**SOUTHWEST MARINE DRIVE
(GRANVILLE STREET TO MACDONALD STREET)
IN-SERVICE ROAD SAFETY REVIEW - FALL 2016**

PREPARED FOR
CITY OF VANCOUVER

URBAN
systems

Figure 9: Strava Global Heat Map – Bicycle Ridership

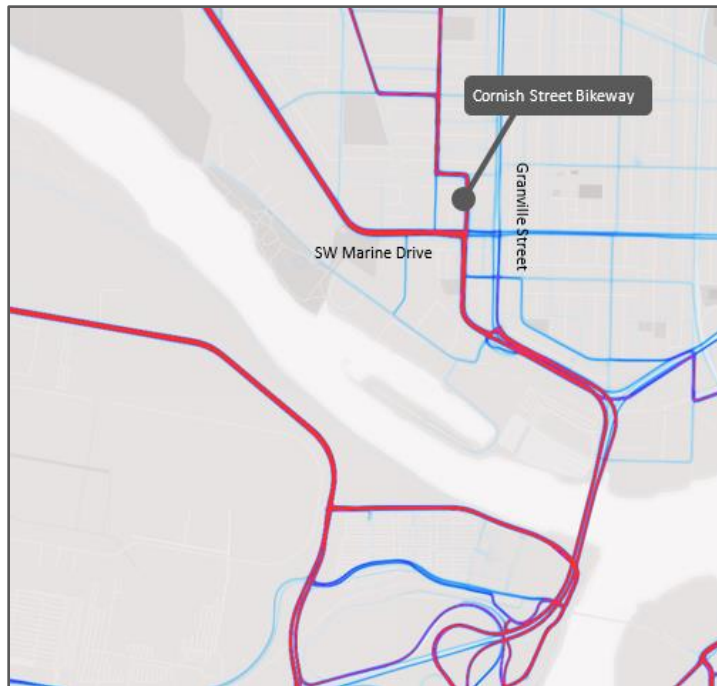
Shared Use Lane Eastbound between East Boulevard and Cornish Street

- Consider restricting right turn motor vehicle movements from eastbound Southwest Marine Drive onto southbound Southwest Marine Drive (Cornish Street Local Street Bikeway) utilizing the space of the existing right turn lane and widening the road into the boulevard to provide space for the bicycle lane to continue to the Cornish Street intersection.

The 100% design drawings provided by the City identifies Cornish Street as a local street bikeway. Therefore, preventing motor vehicle drivers from turning right onto southbound Southwest Marine Drive would reduce the volume of motor vehicles travelling along this portion of the street and reduce the number of motor vehicles using this route as a shortcut to avoid the Granville Street intersection.

As seen in **Figure 9** below, Strava Global Heatmap data indicates that a high number of people cycling are using Cornish Street/Southwest Marine Drive as a bicycle route to access the Arthur Laing Bridge. This helps to confirm the important role this corridor plays in the bicycle network.
